<b>ADDENDUM TO THE CONTRACT DOCUMENTS</b>	<b>Page Number</b> 1	<b>No. of Pages</b> 12
<b>Addendum No. Three (3)</b>	<b>Date Addendum Issued:</b> October 2, 2017	
<b>Issuing Office</b> Alaska State Parks, Design & Construction Section 550 West 7 <sup>th</sup> Ave., Suite 1340, Anchorage, Alaska 99501 Phone: 269-8731 Fax: 269-8917	<b>Previous Addenda Issued</b> One (1) and Two (2)	
<b>Project:</b> Eagle Rock KRSMA Facility Improvements <b>Project No.:</b> 78036-3	<b>Date and Hour of Quotes Due</b> October 11, 2017 at 2:00 prevailing time

### The Contract Documents are Modified as Follows:

BID SCHEDULE  
Eagle Rock KRSMA  
Facility Improvements  
Project No. 78036-3

CONCRETE SIDEWALK & INTERP  
 AREA GRADING PLAN

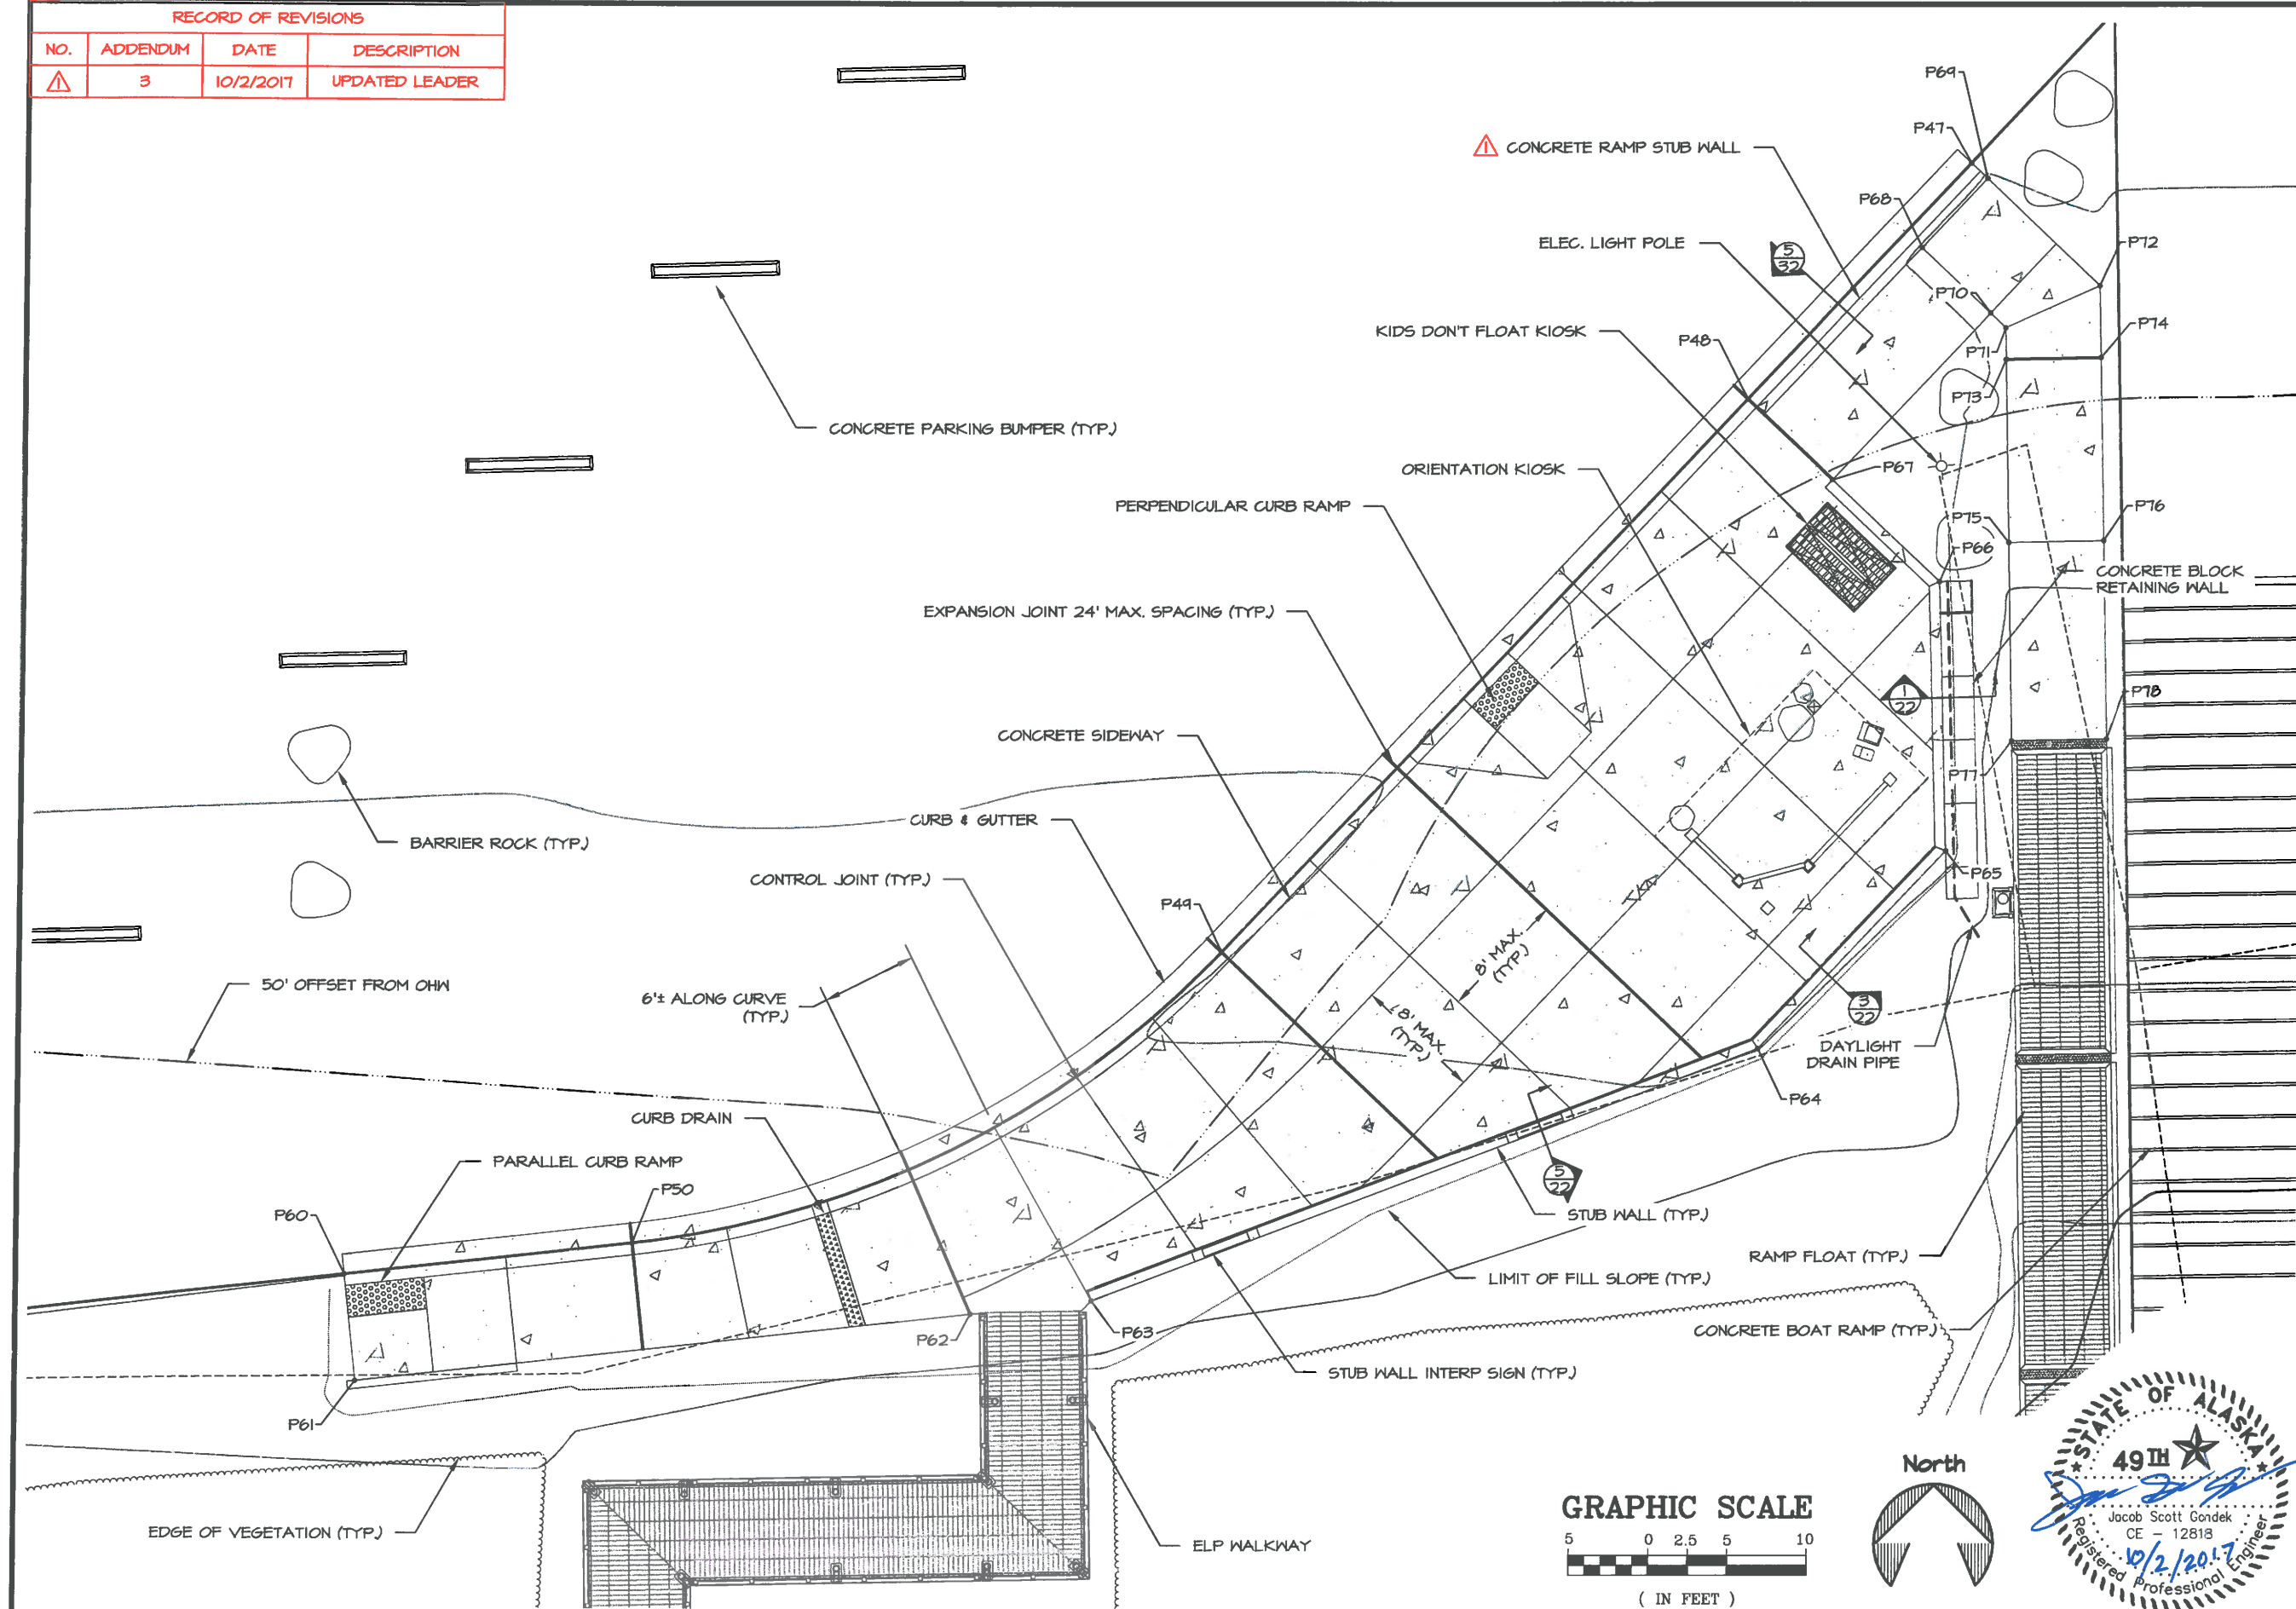
RECORD OF REVISIONS			
NO.	ADDENDUM	DATE	DESCRIPTION
△	3	10/2/2017	UPDATED LEADER

MISCELLANEOUS DETAILS

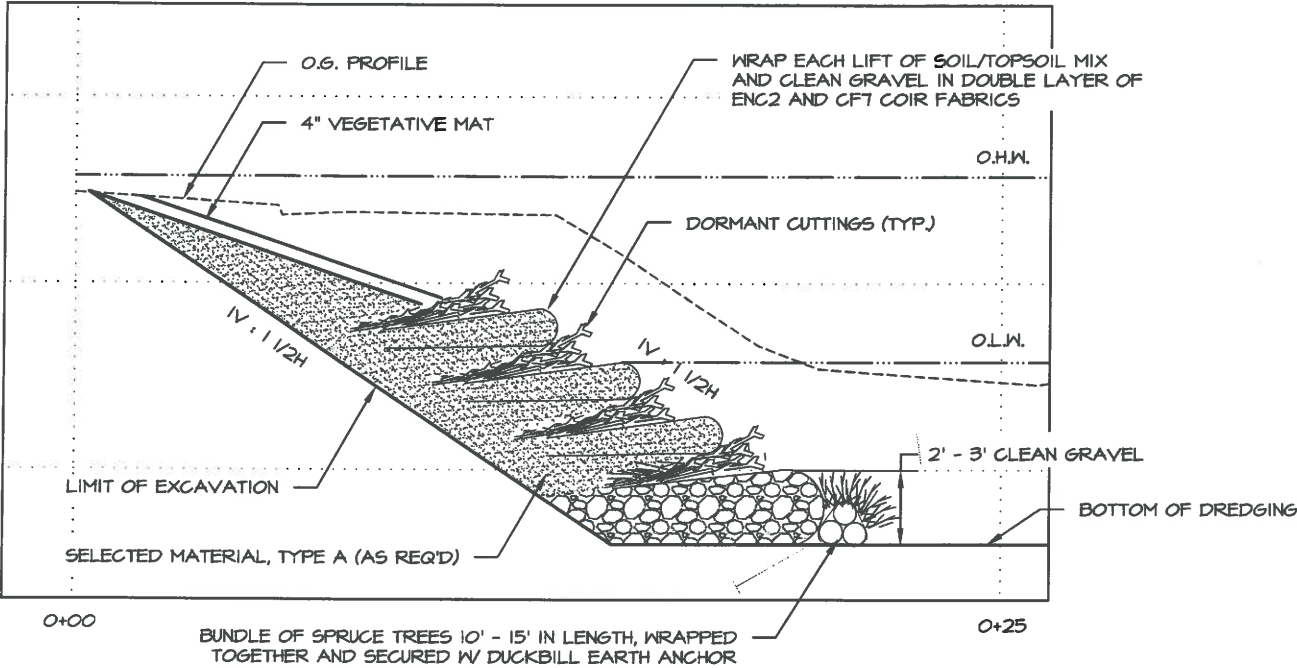
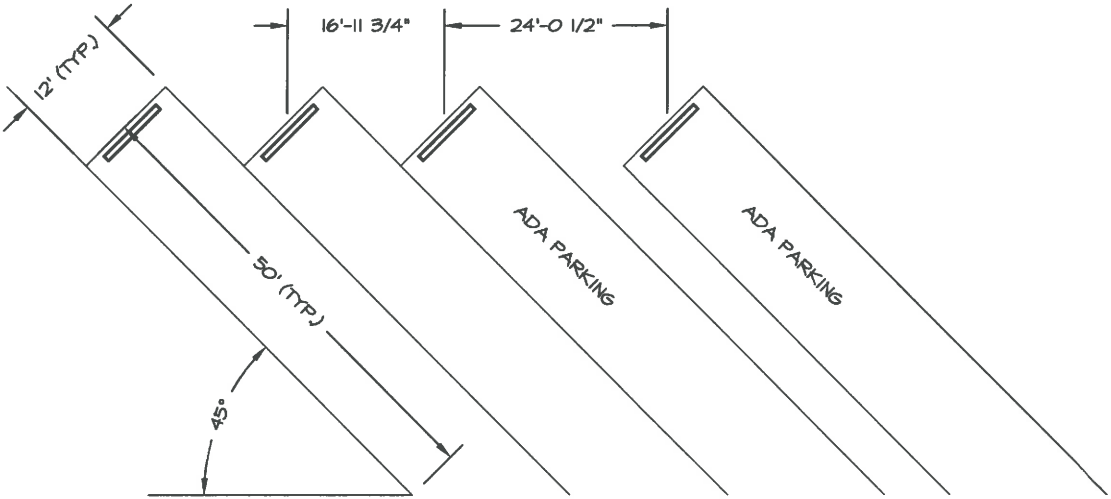
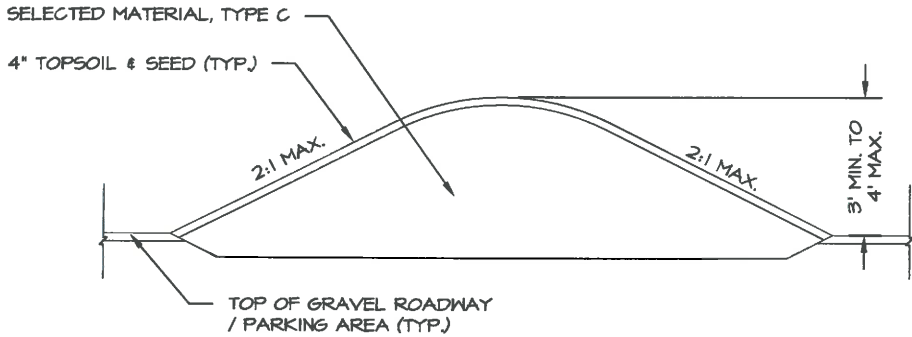
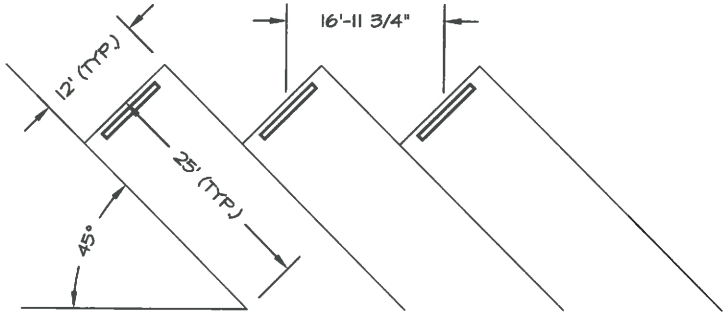
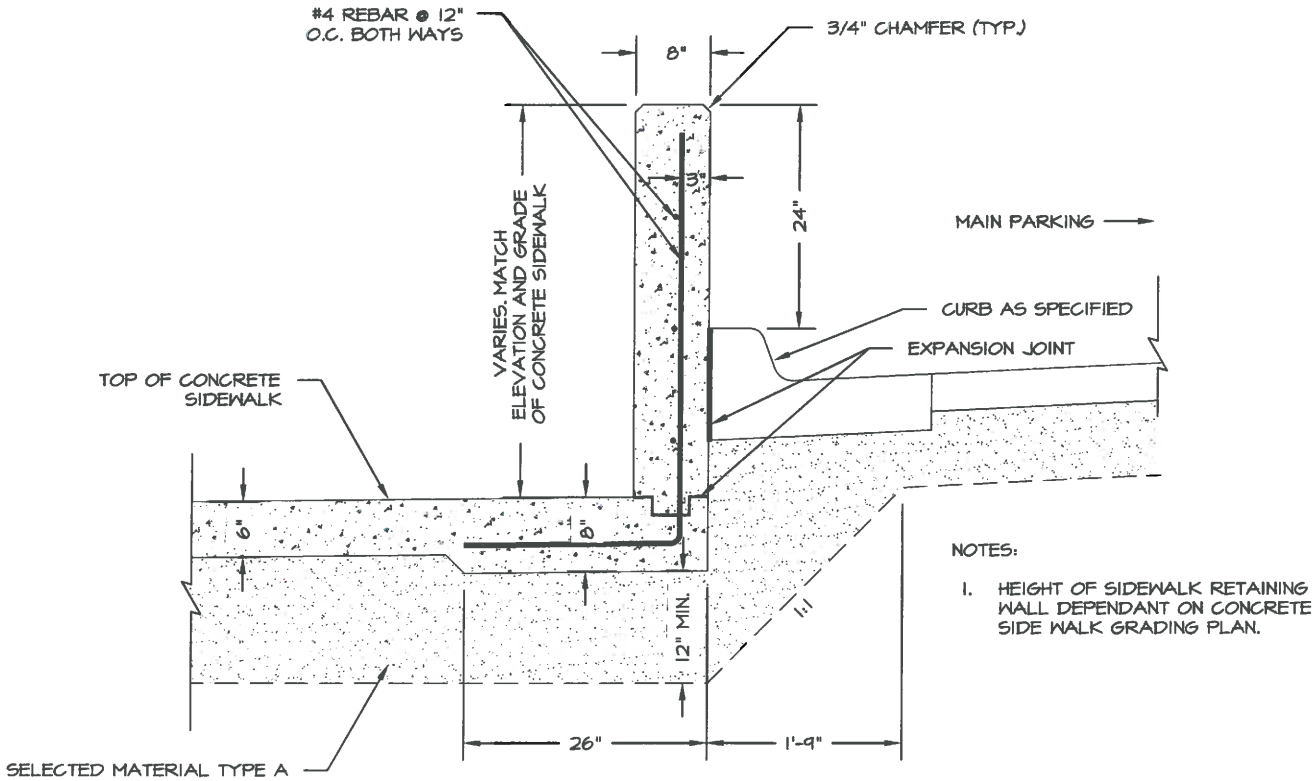
RECORD OF REVISIONS			
NO.	ADDENDUM	DATE	DESCRIPTION
1	3	10/2/2017	RENAME DETAIL
